Failed Inspections for 2024

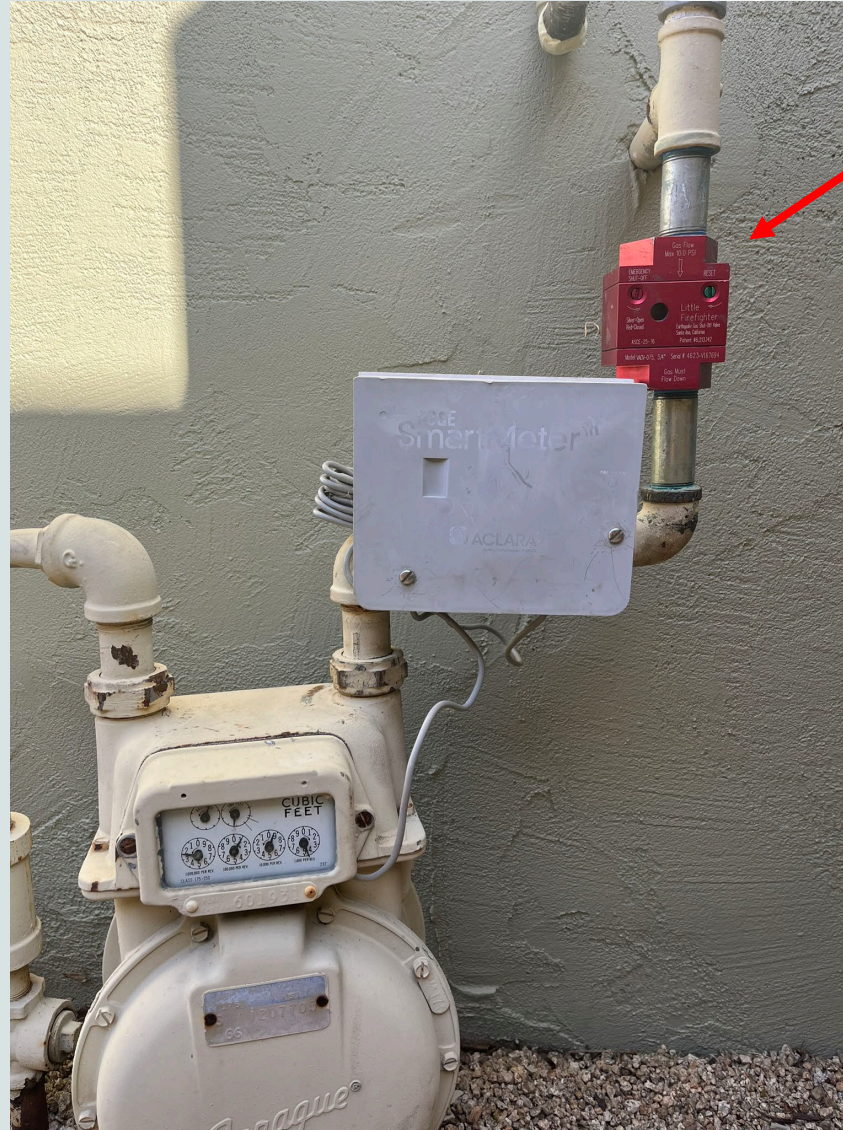
CPC 1211.7: Earthquake shut-off valves installed upside down.

There is even an arrow to help the installer!

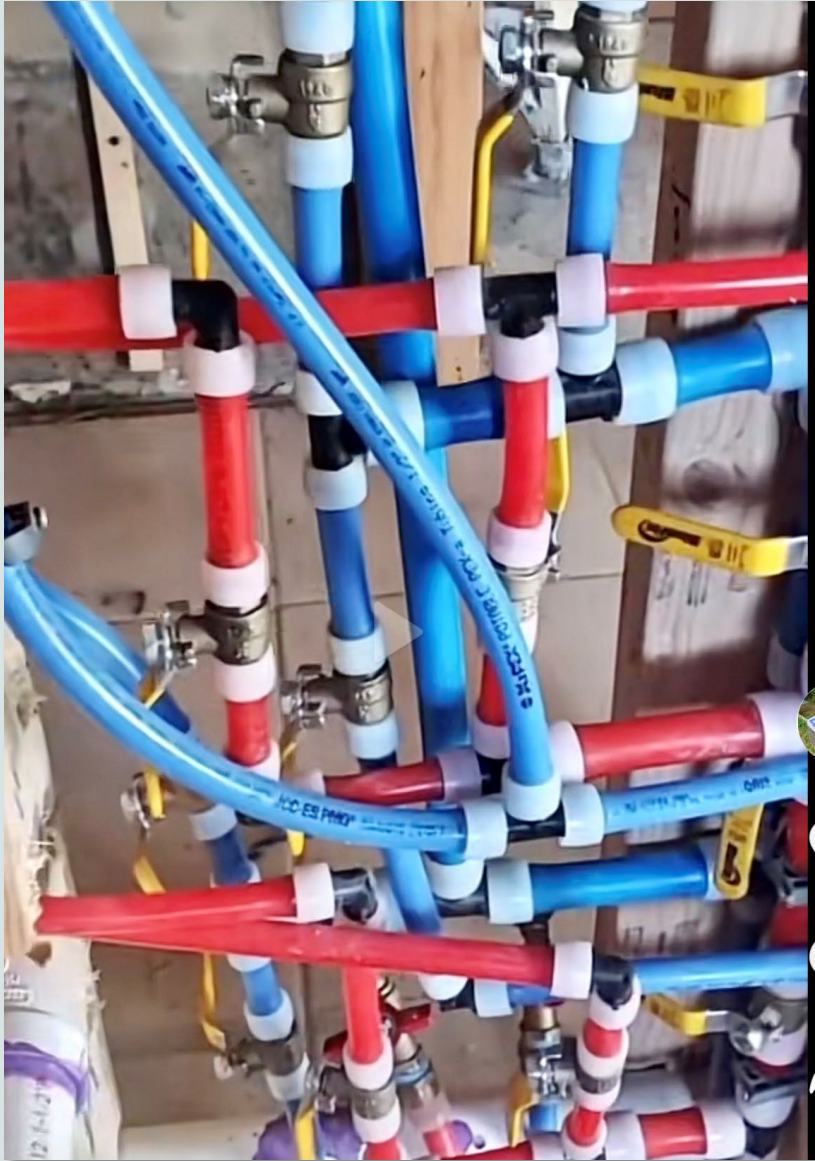
CPC 1004.1 Plumbing systems shall be installed in a neat, workman-like manner.

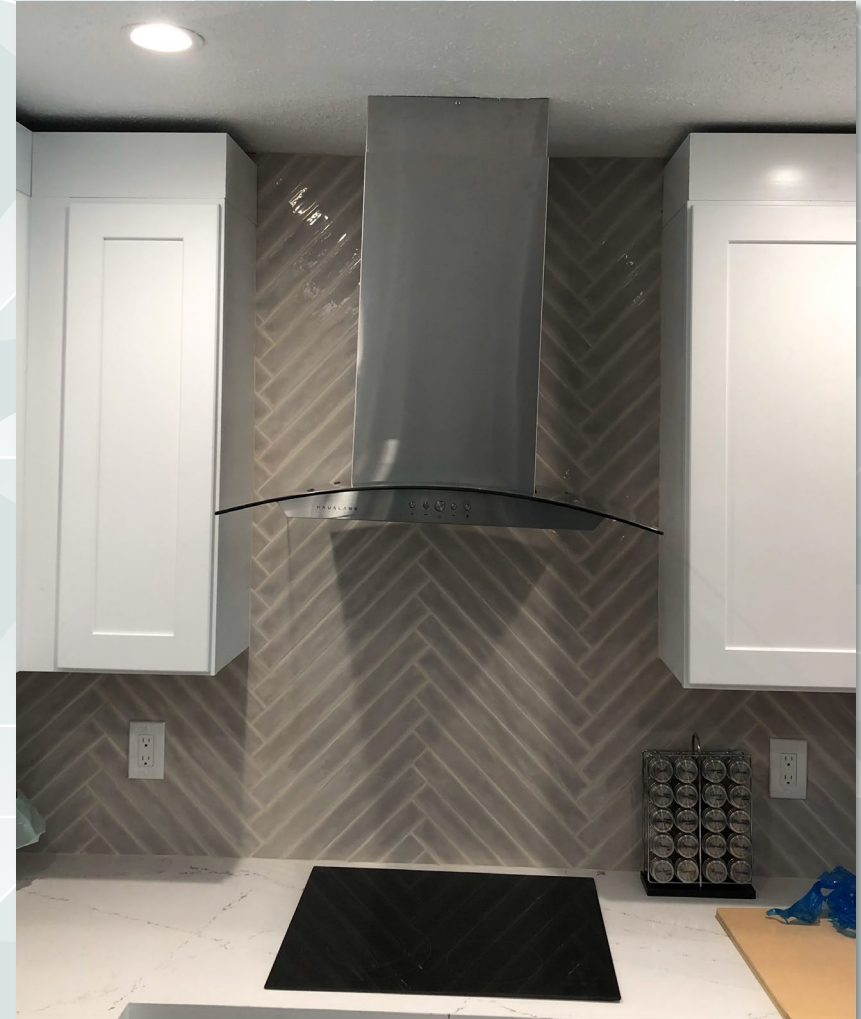
CMC 309.0-3: Design, construction, and workmanship shall comply with accepted engineering practices and shall be of such character as to secure the results sought to be obtained by this code.

Poor craftsmanship – The hood is crooked.

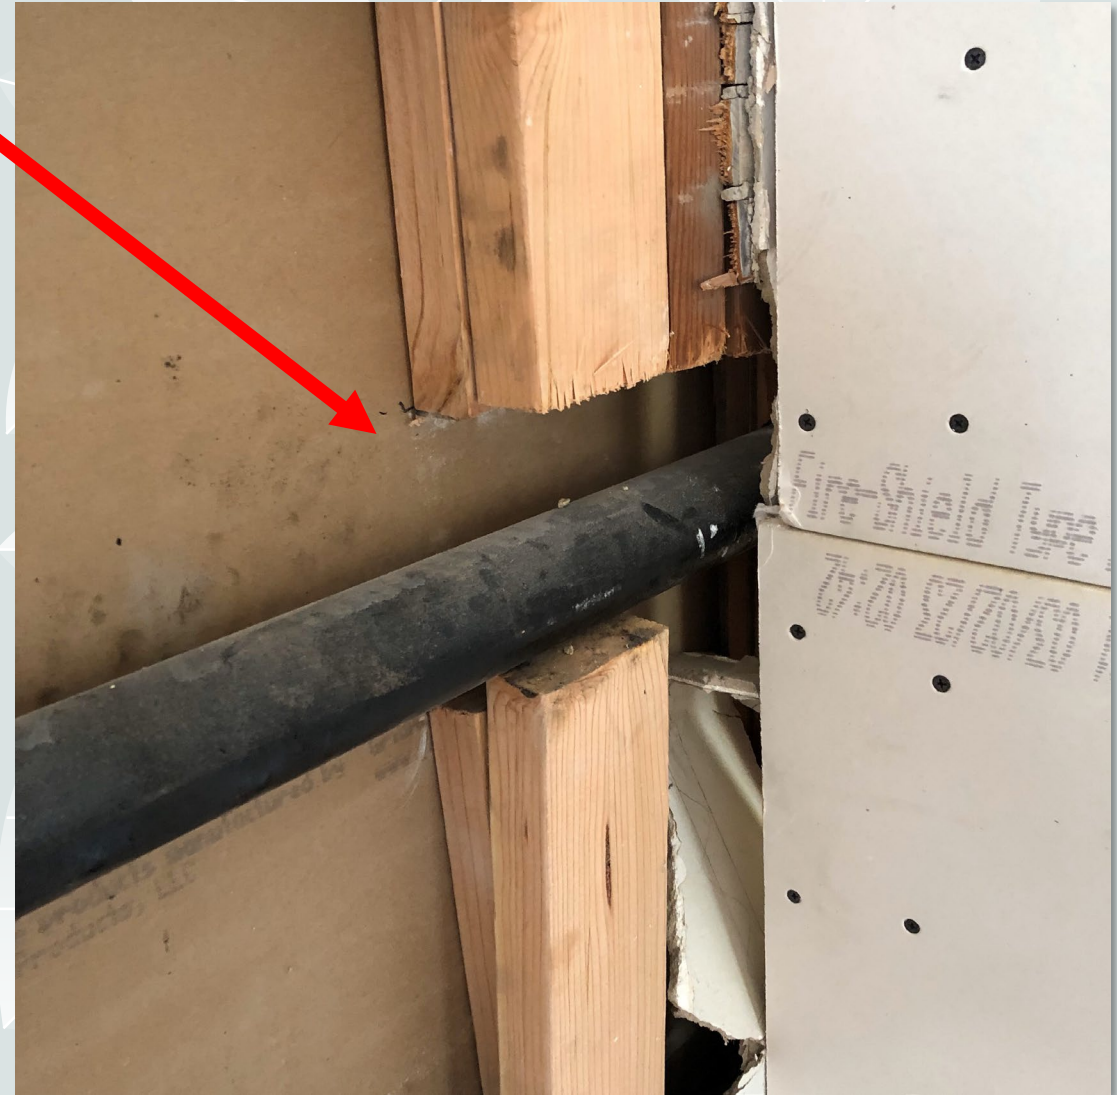
Plans not followed. Structural beam penetrating the roof.

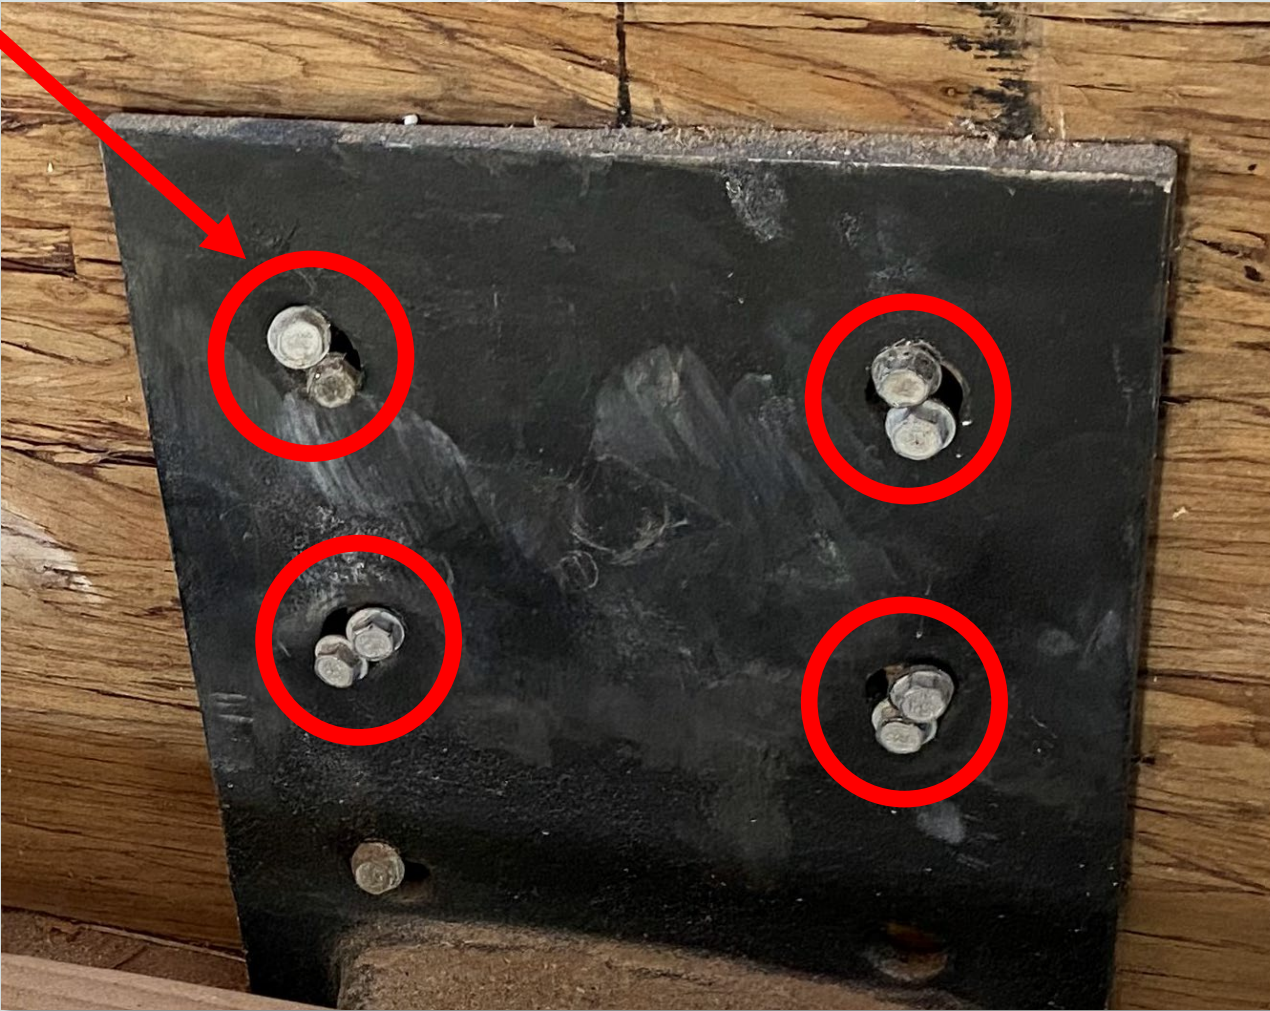
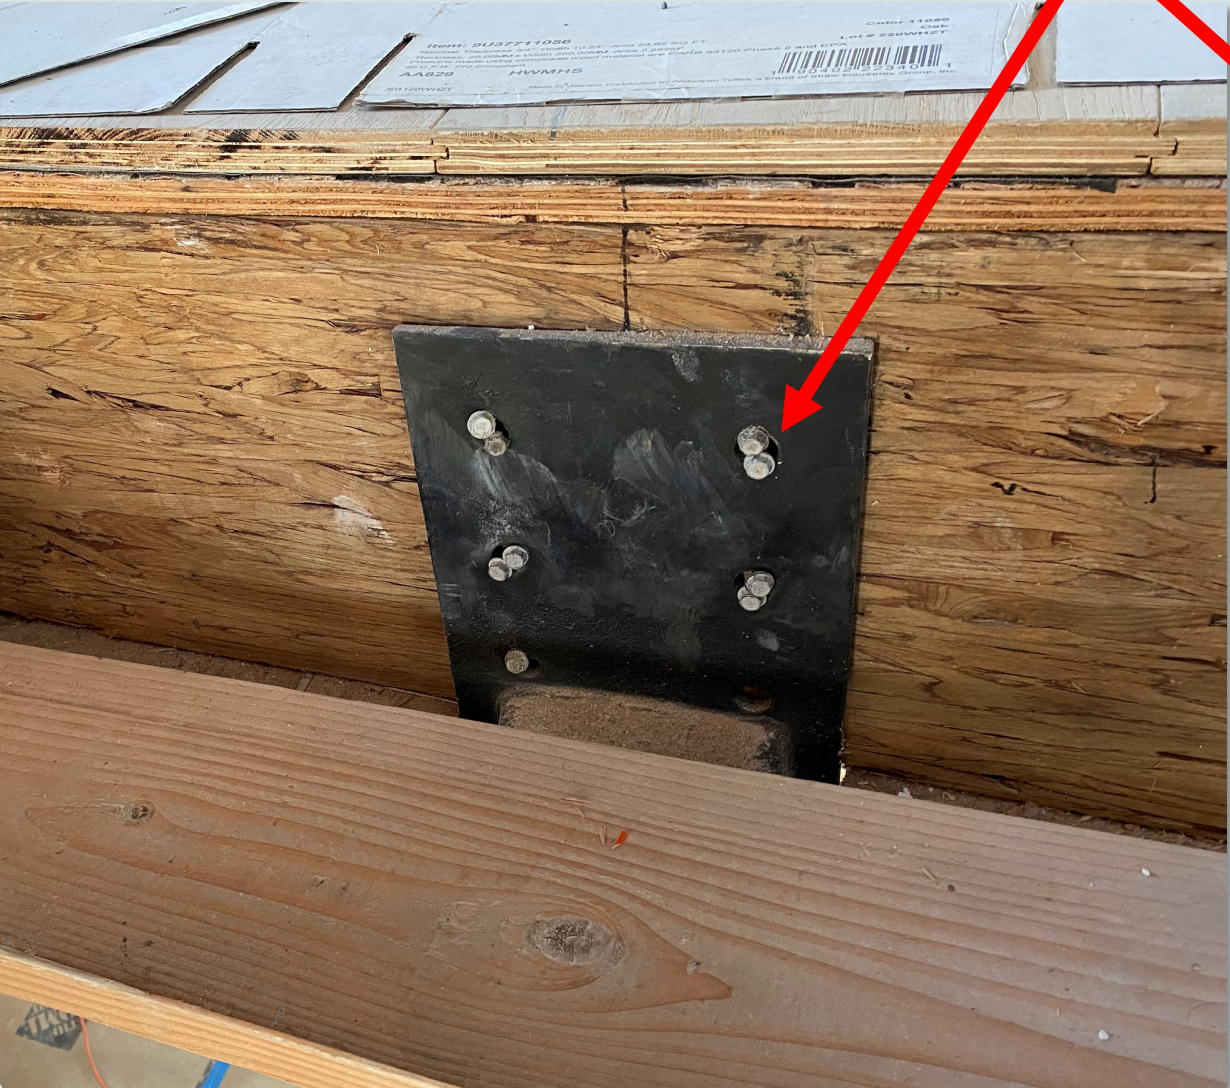
When the plans call for ½ lag bolts, but force in multiple smaller screws into the same hole.

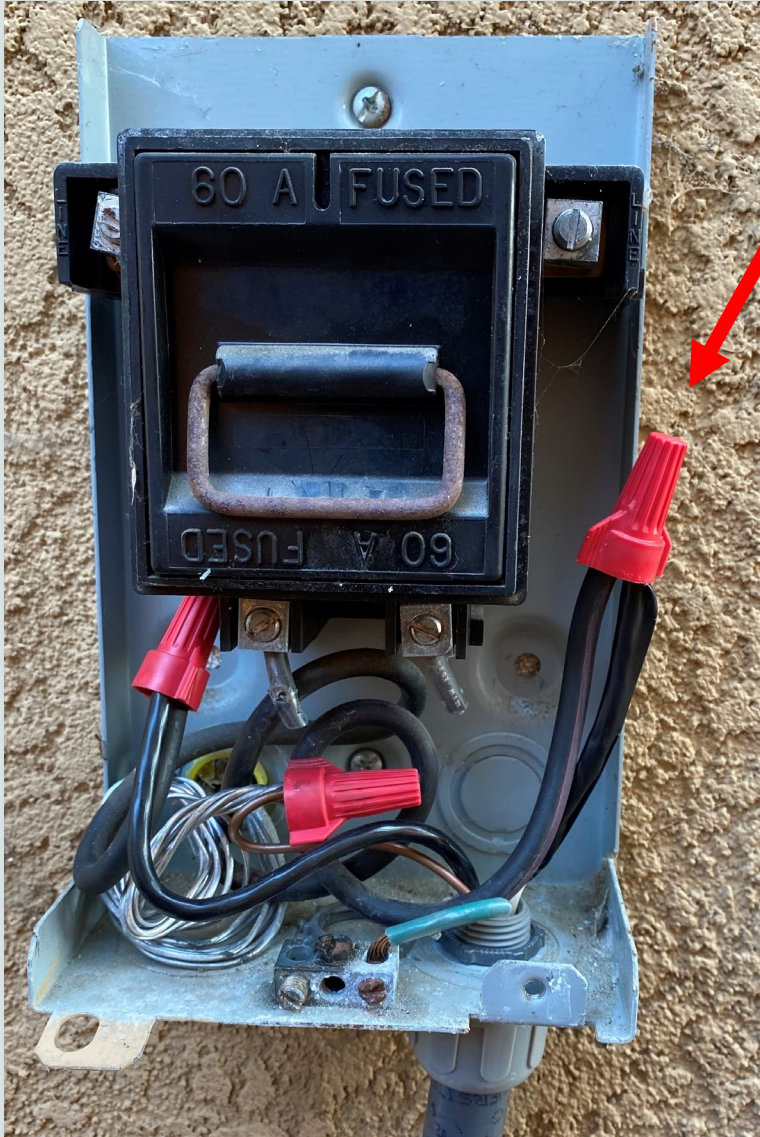
CEC 440.14: The AC fuses have been bypassed.
This is how to kill a service technician! The tech will pull out the disconnect thinking the power is now off. But it is not, there is still 240v going to the unit!

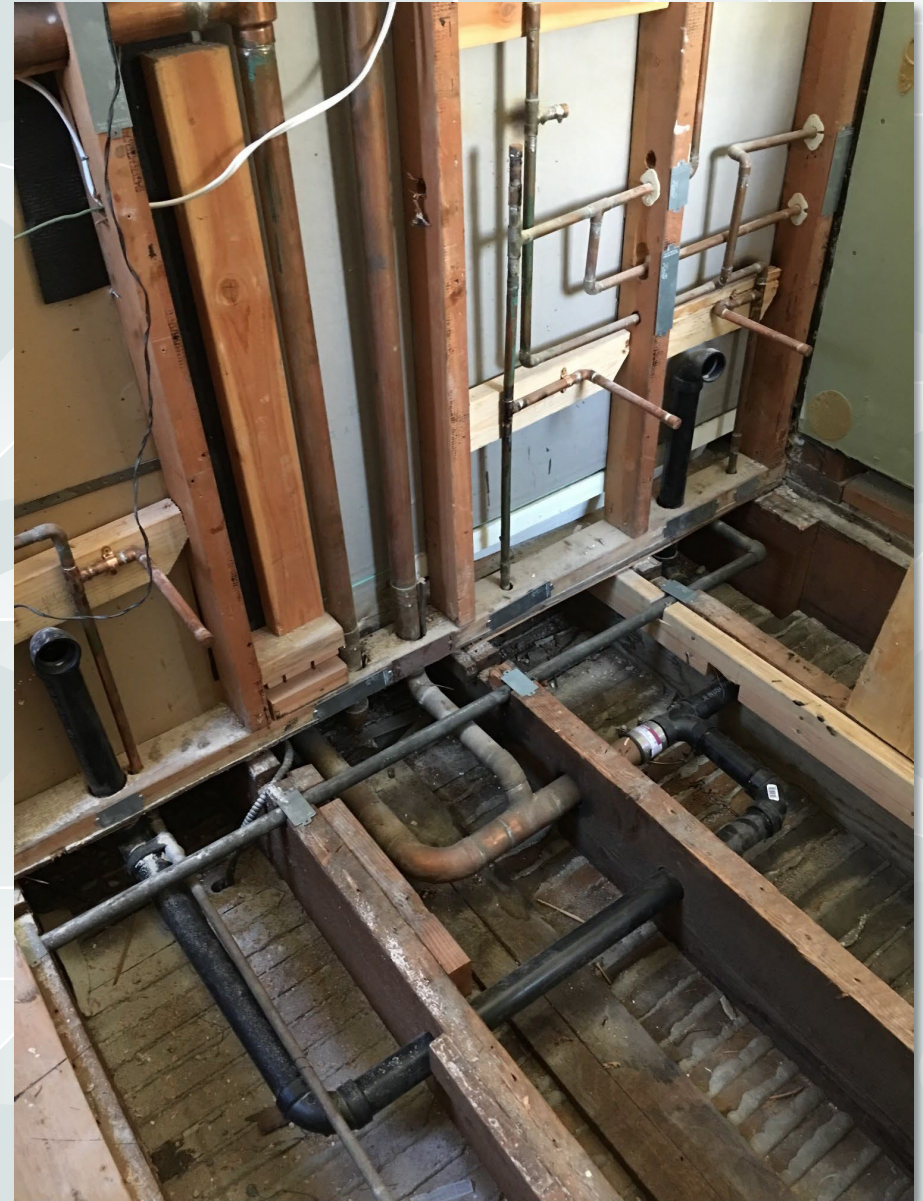
CPC 706: Illegal waste fittings.
CPC 905.3: Improper venting.
CRC 502.8: The floor structure has been compromised.

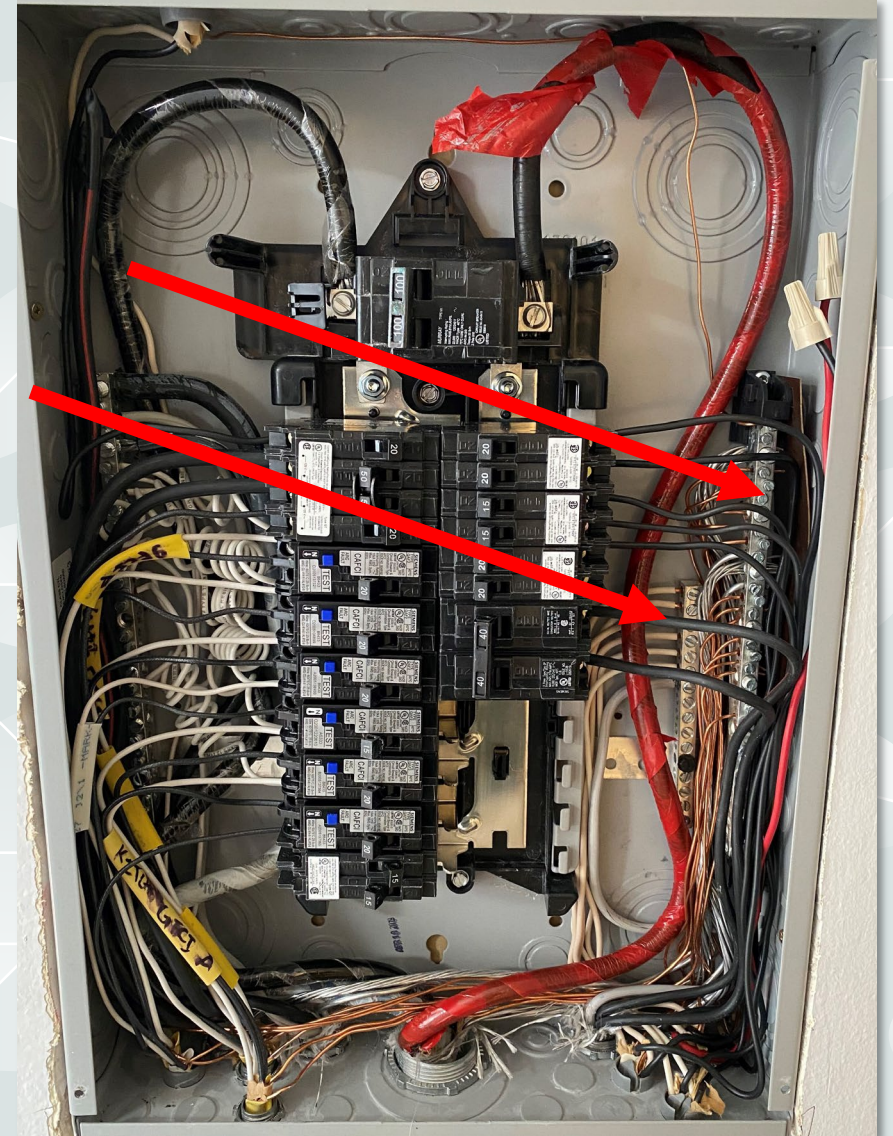
CEC 110.12: All electrical work will be done in a neat, workman-like manner.
